DEPARTMENT OF THE INTERIOR

Bureau of Land Management

Onshore Oil and Gas Operations; Federal and Indian Oil and Gas Leases;

Measurement of Gas

Figure 1

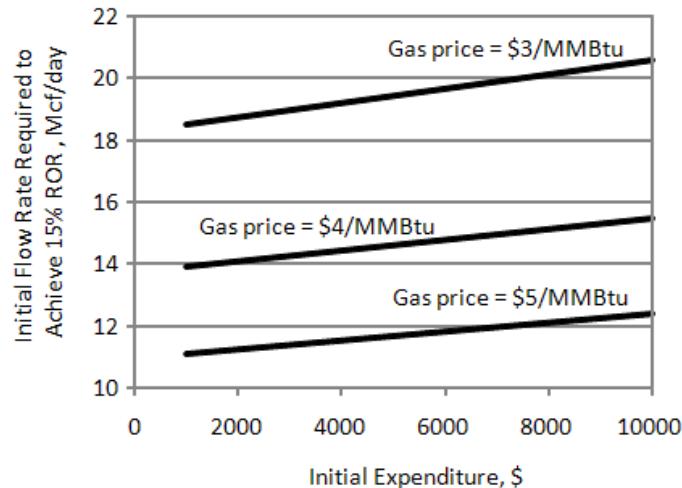
Many commenters questioned how the BLM determined the flow-rate ranges for the four categories of FMPs in the proposed rule (very-low-, low-, high-, and very-high-volume). Several of the commenters stated that the BLM used economics to determine the very-low-/low-volume threshold, but arbitrarily assigned the other thresholds. The BLM does not agree that the low-/high-volume and high-/very-high-volume thresholds in the proposed rule were “arbitrary.” The BLM did not have the same level of detail in its cost data to do the same level of detailed analysis on the thresholds for the higher-volume

The model calculated the minimum initial flow rate needed to achieve a 15 percent ROR for various levels of investment in measurement equipment that would be required of a low-volume FMP. The ROR would be from the continued sale of produced gas that would otherwise be lost if the lease, unit PA, or CA were shut in. Figure 1 shows the results of the modeling for assumed gas sales prices of \$3/MMBtu, \$4/MMBtu, and \$5/MMBtu.

rate at which new natural gas discoveries are made and projected economic growth. Assuming a \$4/MMBtu gas price from Figure 1, a 15 percent ROR could be achieved for meters with initial flow rates of at least 15 Mcf/day, for an initial investment in metering equipment up to about \$8,000. For wells with initial flow rates less than 15 Mcf/day, our analysis indicated that it may not have been profitable to invest in the necessary equipment to meet the proposed requirements for a low-volume FMP. Instead, it would have been more economic for an operator to shut in the FMP. Therefore, 15 Mcf/day was proposed as the default threshold for a very-low-volume FMP, with the AO permitted to approve a higher threshold where circumstances warrant.

Figure 2

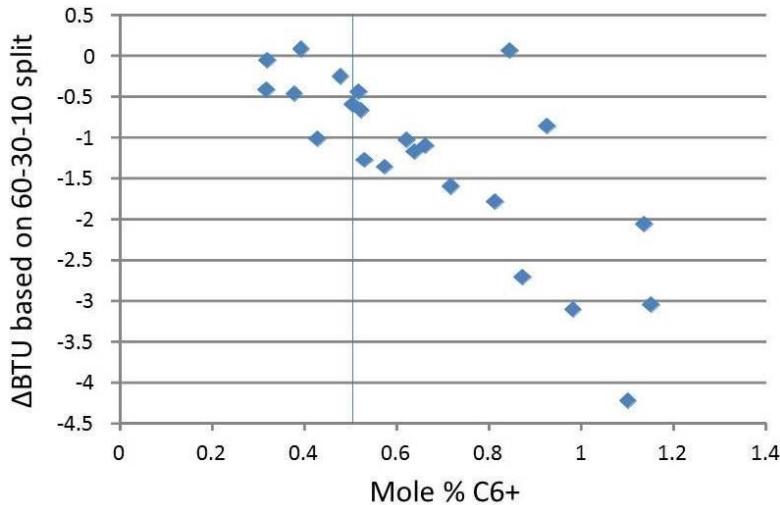
One commenter indicated that the difference in heating value between a C₆+ analysis and an extended analysis is less than the accuracy of the GC, and therefore, is not significant. Several commenters submitted data showing the difference in heating value based on a C₆+ analysis and an extended analysis. The BLM analyzed these data and generated a graph showing the difference in heating value between a C₆+ analysis and an extended analysis as a function of the mole percentage of C₆+, assuming a 60-30-10 split of hexane, heptane, and octane, respectively (Figure 2).

The BLM does not believe that Figure 2, generated from the data supplied by the commenters, supports the commenter's conclusions that the difference between an extended analysis and a C₆+ analysis is less than the accuracy of a GC and is not significant or necessary. To analyze these data, the BLM first determined whether the apparent bias in the data as the mole percent of C₆+ increases is statistically significant. To do this, the BLM used the reproducibility column from Table VI of GPA 2261-13, which gives an indication of the amount of deviation a given component will exhibit when a sample containing that component is analyzed at different laboratories. The BLM then applied these reproducibilities to an assumed gas analysis that resulted in a heating value similar to the heating values supplied by the commenter (approximately 1,119 Btu/scf) using a "Monte Carlo" methodology. From this analysis, the uncertainty in any given heating value is approximately ±2 Btu/scf at a 95 percent confidence level. The threshold of significance, using the definition provided in subpart 3170 is:

In other words, any difference between two data points that is greater than ± 2.8 Btu/scf is statistically significant, and is outside the uncertainty associated with the gas chromatograph that derived these data points. From Figure 2, there are three points that fall outside of the ± 2.8 Btu/scf threshold at the bottom right-hand part of the graph.

from 0.25 mole percent in the proposed rule to 0.50 mole percent in the final rule. Not only does Figure 2 show a bias in the heating value when the mole percent of C₆⁺ exceeds 1.0 mole percent (assuming a C₆⁺ split of 60-30-10 hexane, heptane, and octane, respectively), Figure 2 also suggests a correlation (correlation coefficient of 0.61) between the concentration of C₆⁺ and heating value.

The BLM notes that Figure 2 is based on one data set that contains a fairly narrow range of heating values (1,086 Btu/scf to 1,181 Btu/scf) and, as such, may not be representative of potential bias or correlations that exist outside of that heating value range. Based on the threshold of significance analysis describe above, the BLM agrees that the 0.25 mole percent threshold from the proposed rule is too low and most likely would be less than the uncertainty of most GCs. However, the BLM believes that a threshold of 1 mole percent of C₆⁺ is too high because the evidence supplied by one of the commenters (Figure 2) demonstrates that statistically significant bias is already present when the mole percent of C₆⁺ reaches 1 percent. As a result, the BLM raised the threshold to 0.5 mole percent of C₆⁺, which is one of the thresholds suggested by a commenter. The BLM believes that the 0.5 mole-percent threshold is a reasonable balance between ensuring that heating values are not biased and reducing the economic burden to operators associated with the 0.25 mole percent threshold in the proposed rule.
